REMARKS

Claims 1 - 17 stand rejected under 35 USC 103(a) as being unpatentable over US Patent 6,288,808 to Lee et al (Lee) in view of an article titled "New Multiprotocol WDM/CDMA-Based Optical Switch Architecture" of Benhaddou et al; Simulation Symposium 2001. Proceedings. 34th Annual, 22 - 26 April 2001, Pages 285 - 291 (Benhaddou).

FIG.2

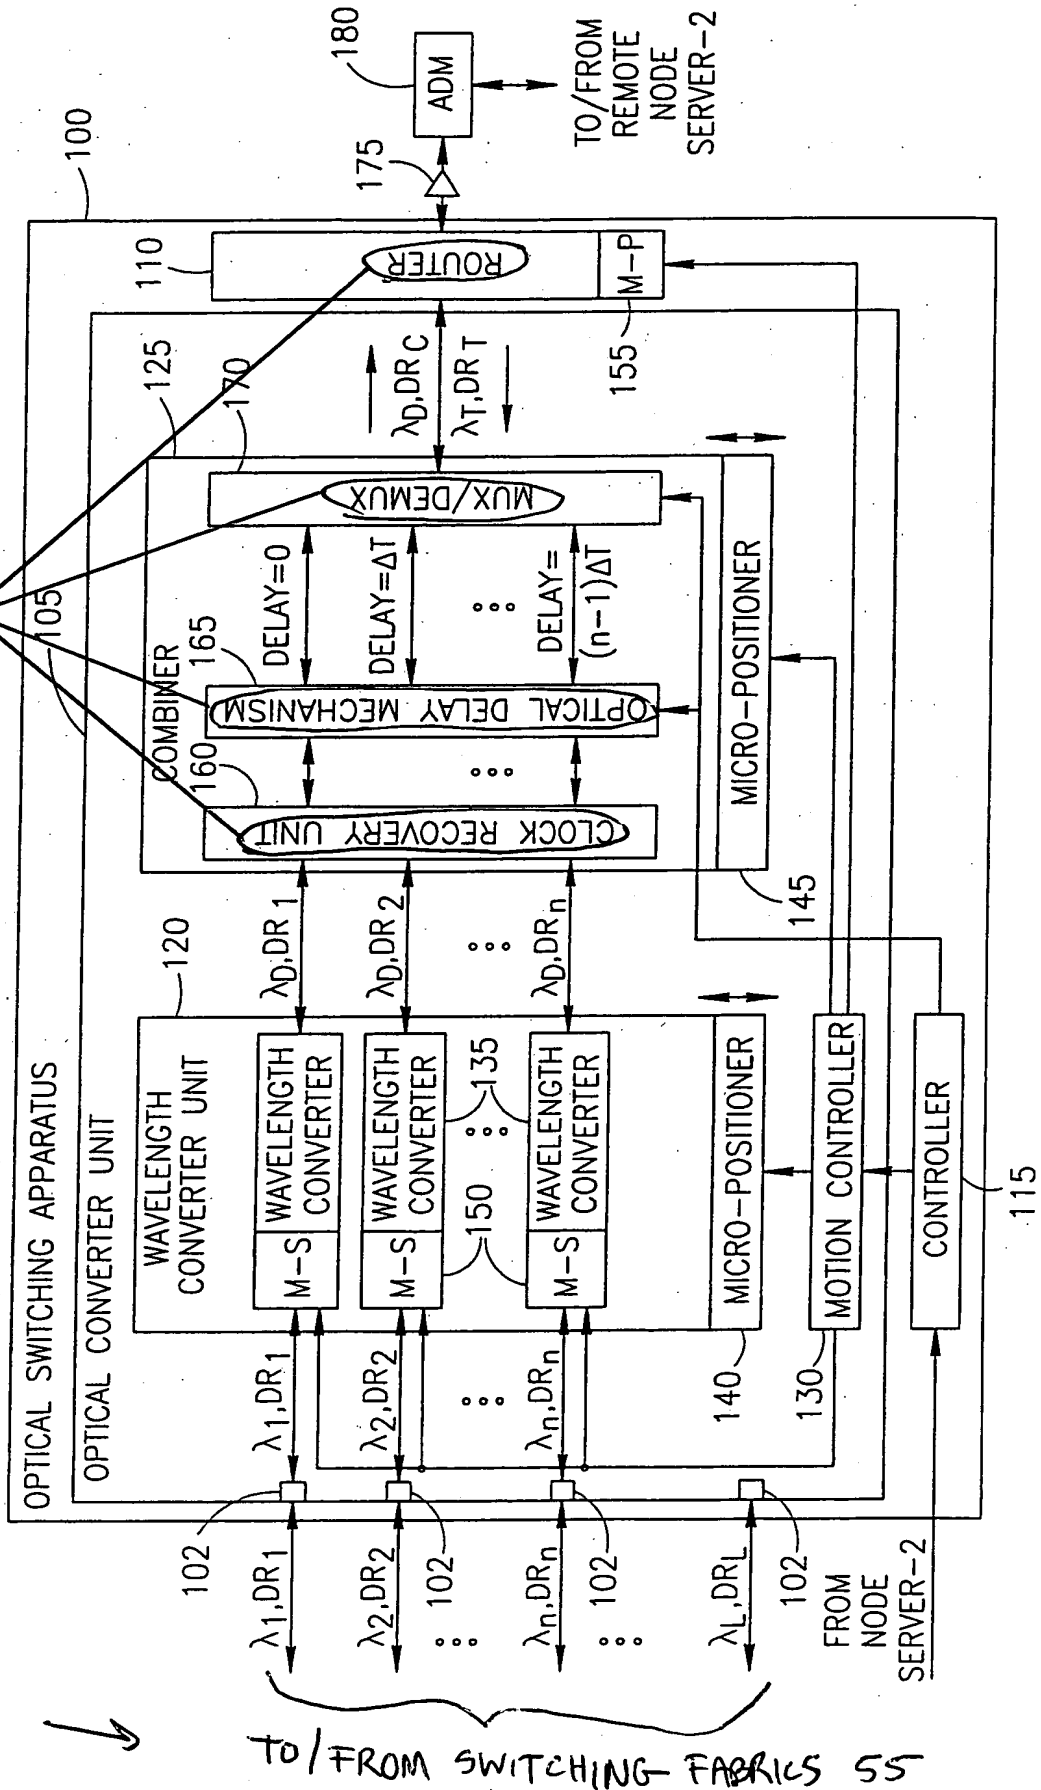
APPEARANCE
OF WORDS
CHANGED

LINK TO
ELEMENT 55
ADDED
